STAFF REPORT

RE: 616 Eaton Street (permit application #7059)

FROM: Karen DeMaria, Urban Forestry Manager,

An application was received for the removal of (1) Spanish Lime tree and (1) Sandbox tree. A site inspection was done on July 21, 2014 and documented the following:

1. Tree Species: #2 Spanish Lime (Melicoccus bijugatus)

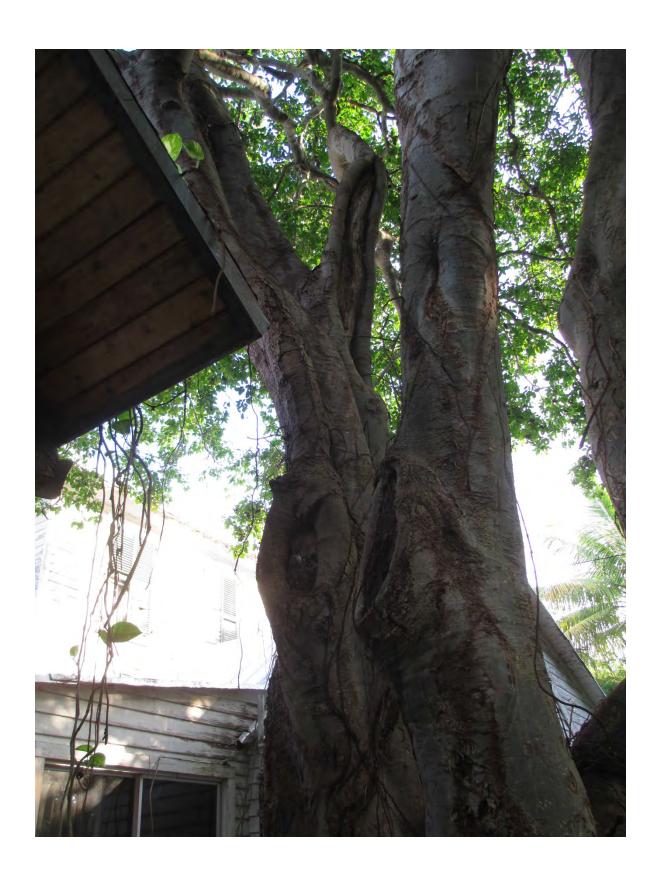
Cavity hole at base of tree-extends straight back at least 1 foot.

Diameter: 39.8"

Location: 60% (backyard tree, growing very close to two historic

Condition: 50% (fair to poor, tree was covered in vines, hole/cavity at

base of tree)

Total Average Value = 70%

Value x Diameter = 27.9 replacement caliper inches
